**CITY OF WEST DES MOINES
PLAN AND ZONING COMMISSION COMMUNICATION**

Meeting Date: February 27, 2017

Item: The Foundry, 111 S. 11TH Street – Approval of Major Modification for Parking and Site Improvements – Rock Island Development LLC – MaM-003257-2016

THE FOUNDRY
 111 SOUTH 11th STREET, WEST DES MOINES, IOWA
LAYOUT PLAN

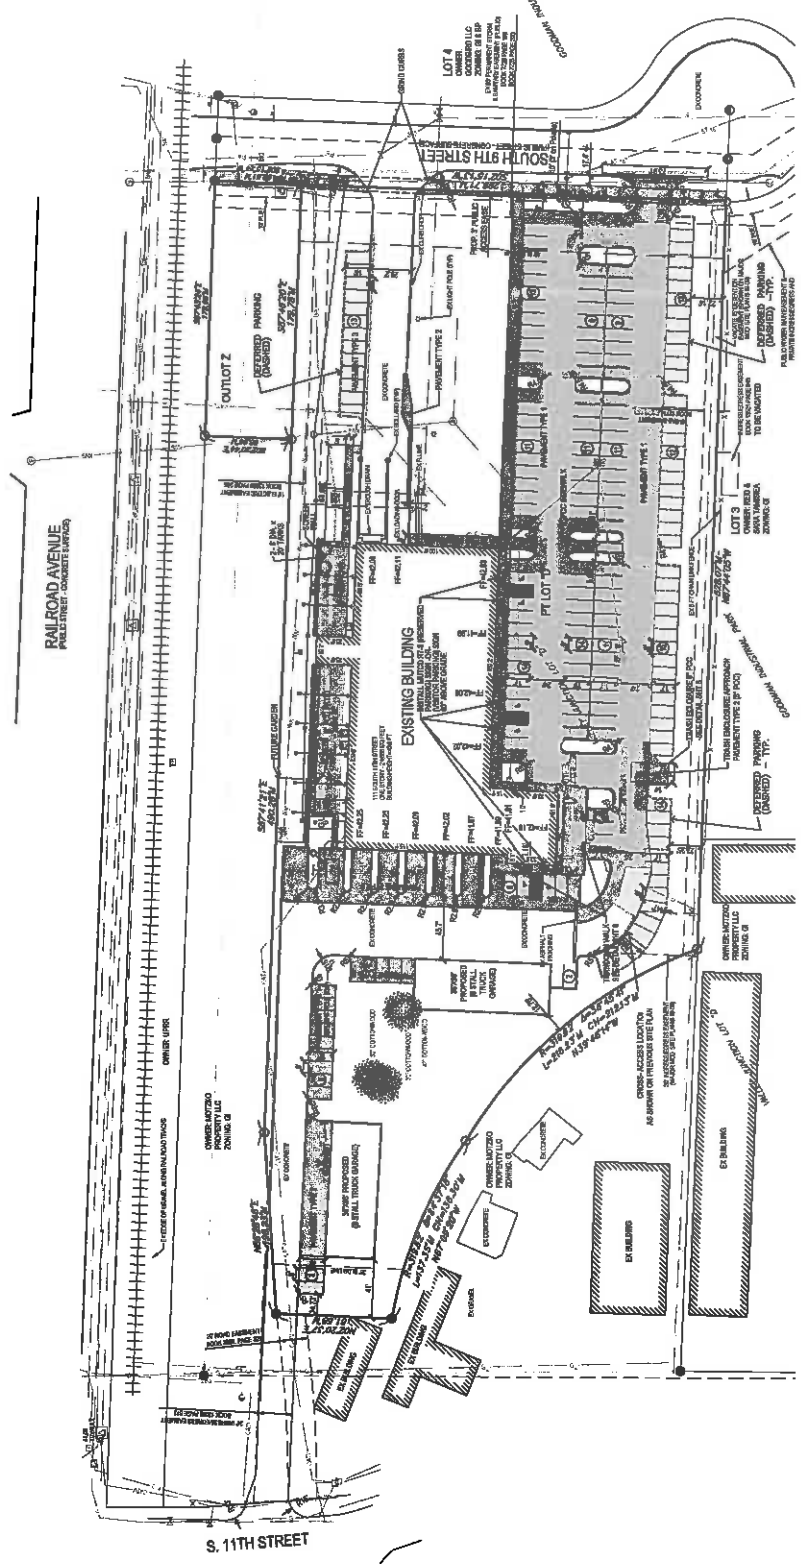
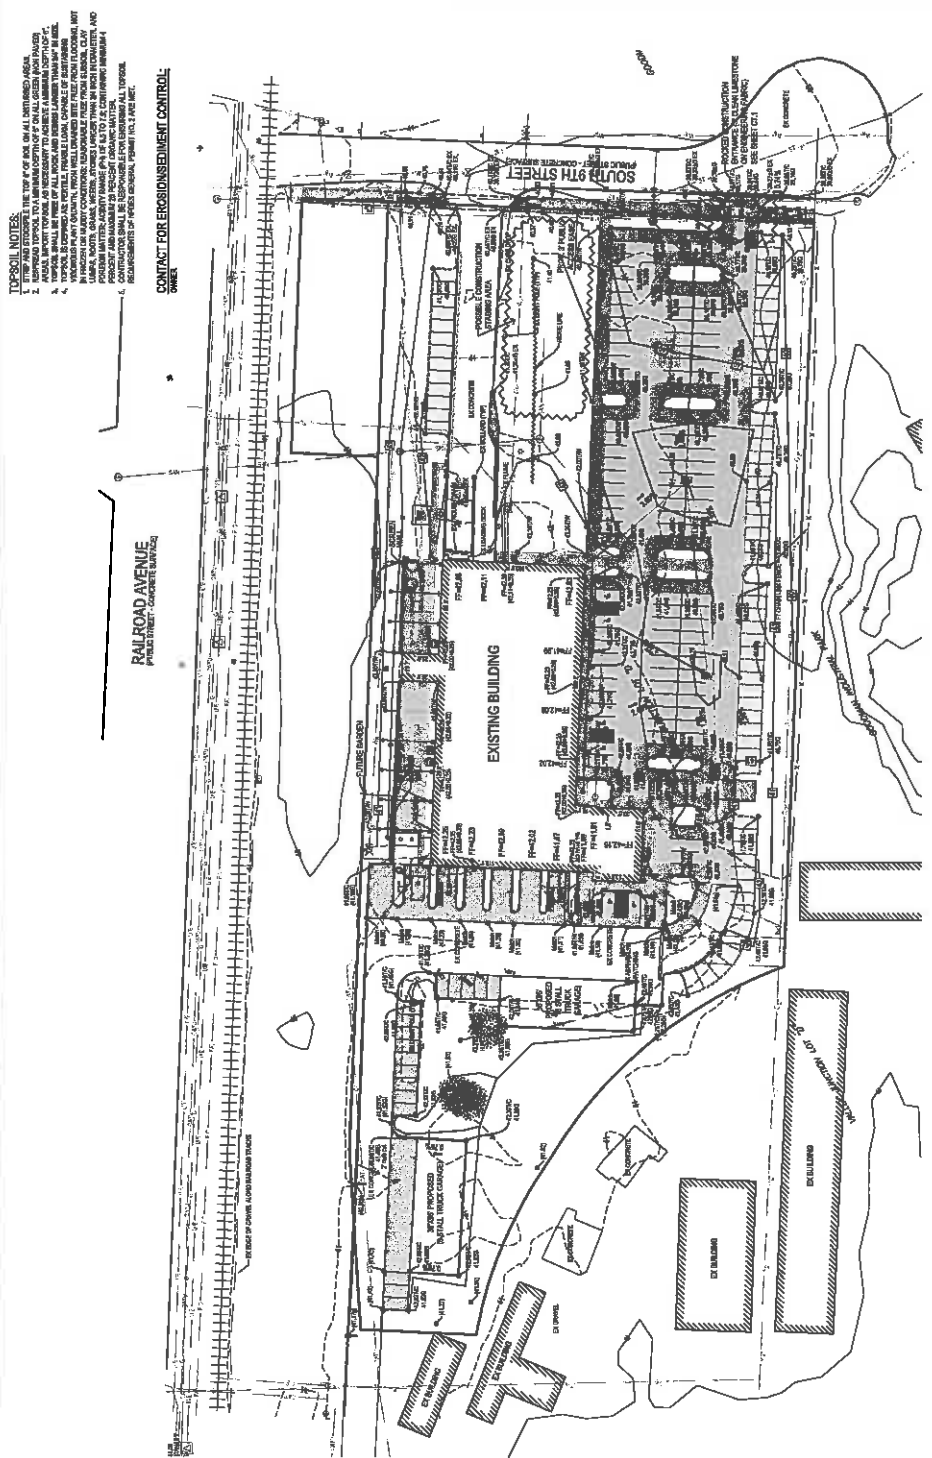
Parking: The three planned uses of the building combined require 190 parking spaces (commercial kitchen = 48 spaces, beer hall with patio = 126 spaces, and the distillery = 32 stalls). The applicant has provided for 196 spaces on site. The applicant requests that a deferral of 67 spaces be approved until such time as the tenant build out of the space or the usage of the building requires all of the parking spaces. The applicant contends that the largest user of the parking will be the beer hall and that the beer hall will operate off-peak of the other two uses and that the distillery will have an operating staff of 5-7 employees, thus not using the full 32 stalls required of the use (see Attachment F – Rick Baumhover e-mail). Staff supports this request as the applicant has demonstrated that all of the parking required for a warehouse building can be accommodated on site. Staff recommends a trigger for the additional parking as outlined in Conditions of approval to be when parking is occurring in places other than the parking lot for the site.

The applicant requests to stage construction of the parking lot by asking for deferment of 67 stalls until such time as the tenants and usage require full build - out. (See most recent set of site plans with deferred areas shown.)

The parking calculation require 190 stalls for the site plans as currently shown (beer hall patio at 2,600 SF). The current plan provides 196 stalls. (6 new stalls just added with latest submittal.)

1. Submit payment for remaining traffic fees prior to review of the major modification by the City Council.
2. Provide final site plan drawings which have addressed remaining staff comments prior to obtaining any building permit.
3. The City Council deferring the installation of 67 parking stalls of the 196 spaces planned for the site plan until such time that the use is causing parking on the grass or other non-designated parking areas or parking off-site is occurring due to the lack of available parking stalls. At the time when the existing parking is not sufficient to accommodate the events held on-site, the City reserves the right to provide the applicant notice

to increase the number of parking stalls. The applicant will be required to provide the additional parking spaces in accordance with City regulations within the first available construction season.
